## **MD15i Carrier joint improvement**

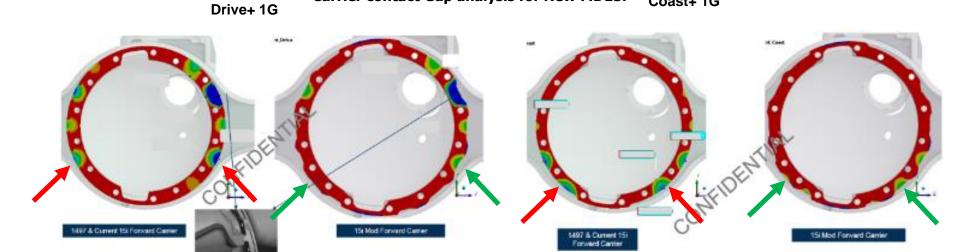
- D Taper Dowel Location

Non-Taper Dowel Location
- (X) Wall thickness, ID Chamfer of 1.5mm additional
- (X) No of Incidents reported
- ☐ In Drive+1G contact gap max 9µ observed.
- □ Gap up to 50µ accepted as per sealant spec.
- ☐ Radial wall thickness increased by 2mm for D1&D5

**Carrier contact Gap analysis for New MD15i**

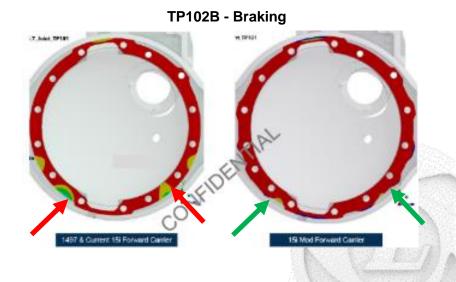
Additional Bolt added and gap reduced to 9µ as above

## MS15i/MR15i Carrier joint improvement

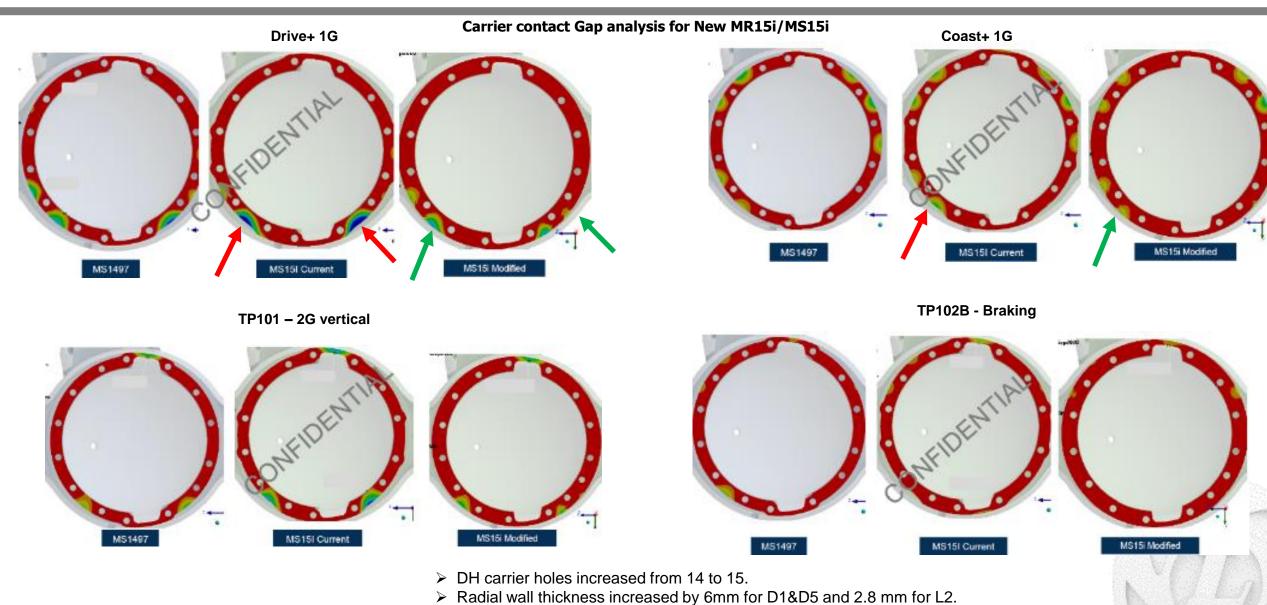
> Design is protected for 14 & 15 holes.
